**MITSUBISHI FUSO**  
TRUCK OF AMERICA, Inc.

**EQUIPMENT RECALL NOTIFICATION – C1003910 Replacement Halogen Sealed Beam High Beam Headlamp  
NHTSA EQUIPMENT RECALL – 09E-010**

### **EQUIPMENT RECALL NOTIFICATION – C1003910 Replacement Halogen Sealed Beam High Beam Headlamp NHTSA EQUIPMENT RECALL – 09E-010**

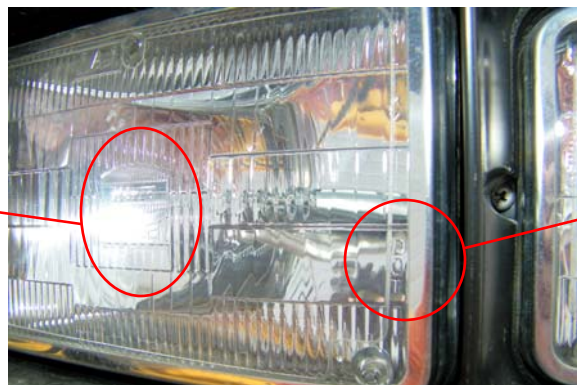
Mitsubishi Fuso Truck of America, Inc. has decided that certain replacement halogen sealed beam high beam headlamps sold as spare parts between October 24, 2007 and December 2, 2008, fail to conform to the requirements of Federal Motor Vehicle Safety Standard No. 108, "Lamps, Reflective Devices, and Associated Equipment." These headlights were designed for use on right-hand drive vehicles in Japan. Accordingly, their aiming pattern is incorrect for the U.S. and they could cause glare in the eyes of oncoming drivers or fail to properly illuminate sections of the roadway. Accordingly, their use could cause a crash. The affected headlamps do not bear a "DOT" imprint in the face of the lamp, as shown below.

Please return all MR339043 headlamps in parts inventory immediately for credit, and identify all customers who have purchased the affected replacement high beam headlamp. Please contact the customers that can be identified as purchasers and have them immediately inspect their vehicle's high beam headlamps for a "DOT" imprint in the face of the lamp. The headlamps that must be inspected are the inner two high beam lamps (as shown below).

Incorrect headlamps bear only the markings shown below left, and do not bear the "DOT" imprint shown below right.

If your customer determines that an affected headlamp has been installed on their truck, please have them schedule an appointment to have the headlamp replaced. Order replacement headlamp MK580140 and install in place of affected headlamp MR339043. After repair completion, file a Warranty Service Claim A through Fusonet using the following information:

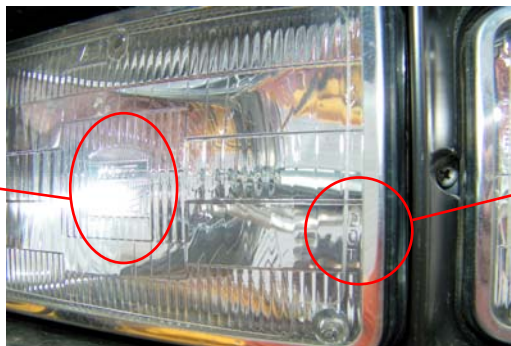
Mitsubishi Fuso Truck of America, Inc. has decided that certain replacement halogen sealed beam high beam headlamps sold as spare parts between October 24, 2007 and December 2, 2008, fail to conform to the requirements of Federal Motor Vehicle Safety Standard No. 108, "Lamps, Reflective Devices, and Associated Equipment." These headlights were designed for use on right-hand drive vehicles in Japan. Accordingly, their aiming pattern is incorrect for the U.S. and they could cause glare in the eyes of oncoming drivers or fail to properly illuminate sections of the roadway. Accordingly, their use could cause a crash. The affected headlamps do not bear a "DOT" imprint in the face of the lamp (as shown in the photos on reverse side of this notification).

Since it is possible that the affected replacement high beam headlamp could have been installed on your vehicle, MFTA asks that you inspect your vehicle's high beam headlamps for a "DOT" imprint in the face of the lamp as shown in the following photographs. The headlamps that must be inspected are the inner two high beam lamps (as shown below). If you find that your headlamps do not bear the "DOT" imprint, you should contact your nearest Mitsubishi Fuso dealer and arrange to have the headlights replaced.

Affected headlamps do not bear the markings below left, and do not bear the "DOT" imprint shown below right.

The halogen sealed beam high beam headlamp will be replaced with proper headlamps on all affected vehicles at no cost to you. The scheduled time for headlamp replacement is 0.6 hours.
